NL-03-0753

VOGTLE ELECTRIC GENERATING PLANT
REQUEST TO REVISE TECHNICAL SPECIFICATIONS
REACTOR TRIP SYSTEM INSTRUMENTATION OVER TEMPERATURE DELTA
TEMPERATURE (OTΔT) AND OVER POWER DELTA TEMPERATURE (OPΔT)
REACTOR TRIP FUNCTIONS
REQUEST FOR ADDITIONAL INFORMATION
(REFERENCE: TAC NOS. MB 5046 and 5047)

RESPONSES TO REQUEST FOR ADDITIONAL INFORMATION

Figure 1

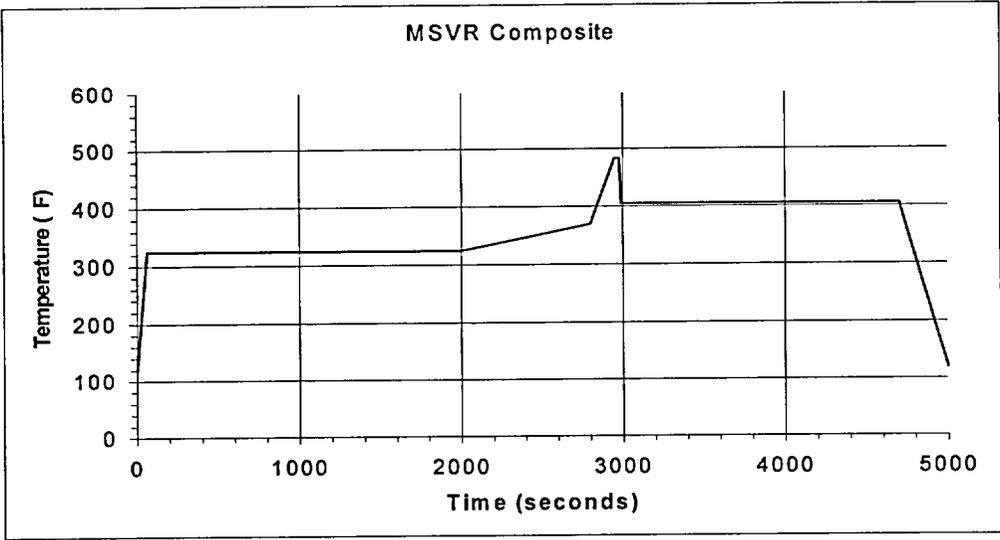
Provide curves of pressure and temperature as a function of time for the HELB outside containment.

Eighty five cases were run to construct a composite temperature profile. The composite profile is shown in Figure 1 below.
